Subsurface Consultants, Inc.

May 1, 1997 SCI 1039.002

Response to Information/Revisions Request Risk Based Corrective Action Assessment Tank Area B 718 San Pablo Avenue Albany, California

SKETCH OF CONTAMINATED SOIL AREA

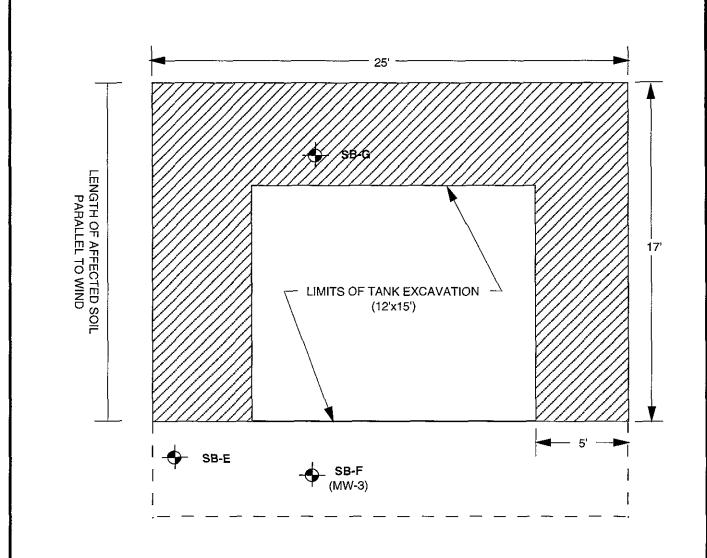
Technical rationale for using the value of the length of affected soil parallel to wind and contaminated soil area:

As described in the report, the contaminated soil area was defined as extending 5 feet beyond the original excavation limits. The original excavation areal extent was 12' by 15'. However, four samples collected from borings SB-E and SB-F on the east side of the tank excavation limits

indicated no petroleum hydrocarbon impacts. Thus, assuming a 5-foot lateral extension from three sides of the excavation limits results in an areal extent of 17 feet by 25 feet, minus the original area which was excavated out. Therefore, the areal extent of impacted soils is (17x25) - (12x15) = 245 square feet or 2.3×10^5 square centimeters as shown in Output Table 1. See the attached sketch for visual clarification.

In general, the wind direction at the site is from the west to the east. Using the rationale for the contaminated soil area described above, a 17-foot length (rounded to 20 feet) was used for the length of affected soil parallel to wind. See the attached sketch for visual clarification.
